April 14, 2026
Subject: Donald V. Carter Bridge
Wearing
Surface Replacement
WIN:029528.00
Location: Winslow-Waterville
Amendment No. 1

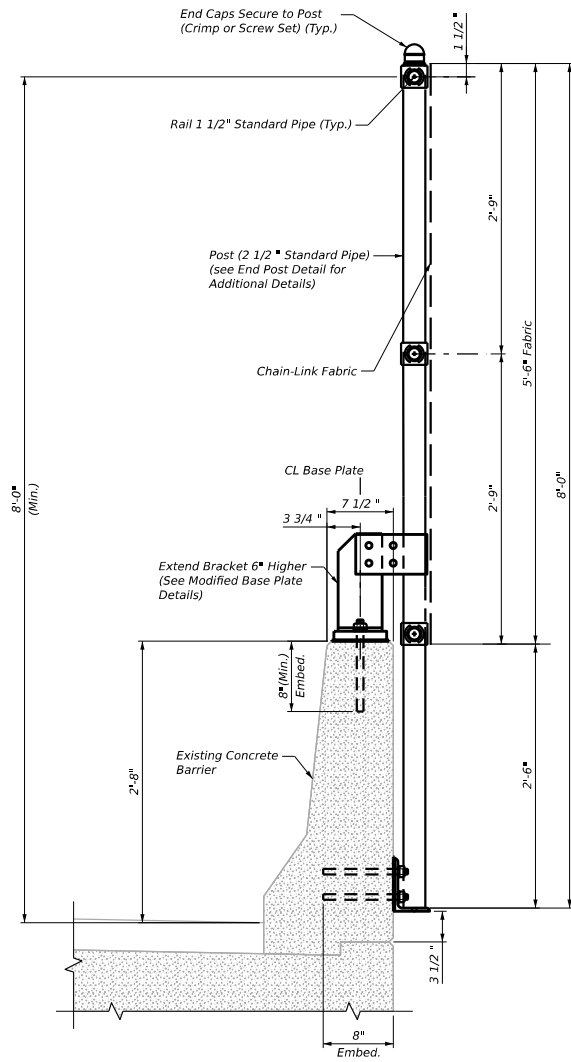
Question: See plate mounted post marked up drawing - I believe this option would save thousands of dollars and provide the same amount of coverage. Only concern would be anchor bolts interfering with the reenforcing bar in the concrete wall

Response: Mounting the chain link security fence to the top of the concrete barrier only, will not be acceptable.

CONNECTION DETAIL - SECURITY FENCE
 (SIMILAR UPDATES REQUIRED AT ANTI-CLIMB SHIELDS)

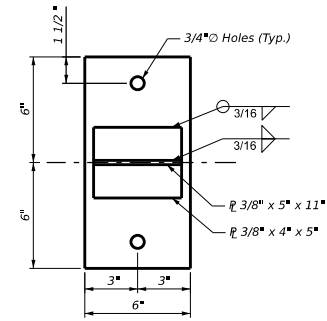
Question: Item 607.181 8' high chain link security fence - The plans show the fence being mounted to the side of the concrete wall and the chain link fence fabric extending down to the bottom of the wall. For this to be installed using this design would require the use of a very large snooper truck or a helicopter and a trapeze artist. If the fence is shortened up in the section in front of the concrete wall, that i believe is not needed, this would raise the bottom rail to the top of the wall where the proper hardware could be applied without being on the backside of the bridge. See attached marked up drawing.

Response: Modifying the design plan details to reduce the height of the chain-link fence fabric and associated horizontal components is acceptable. The revised fence fabric limits shall, at a minimum, extend from the top of the existing concrete barrier. The vertical fence posts shall continue to be mounted at both the top of the barrier and the fascia (outside face of the barrier), in accordance with the design plan details.
